**Economic Commission for Europe****Inland Transport Committee****World Forum for Harmonization of Vehicle Regulations****Working Party on Passive Safety****Fifty-eight session**

**Regulation No. 16 (Safety-belts)****Proposal for the 07 series of amendments to Regulation No. 16 (Safety-belts)****Submitted by the experts from the European Commission, Japan and Republic of Korea \***

## "Annex 2

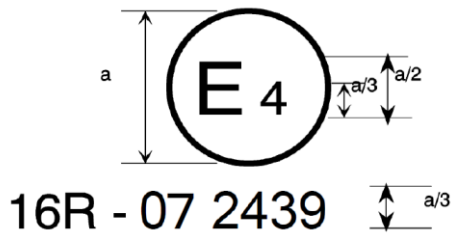
The above approval mark affixed to a vehicle shows that the vehicle type concerned has, with regard to safety-belts, been approved in the Netherlands (E 4) pursuant to Regulation No. 16. The approval number indicates that the approval was granted according to the requirements of Regulation No. 16 as amended by the **07** series of amendments.

The above approval mark affixed to a vehicle shows that the vehicle type concerned has been approved in the Netherlands (E 4) pursuant to Regulations Nos. 16 and 52.<sup>1</sup> The approval numbers indicate that, at the dates when the respective approvals were given, Regulation No. 16 included the **07** series of amendments and Regulation No. 52 the 01 series of amendments.
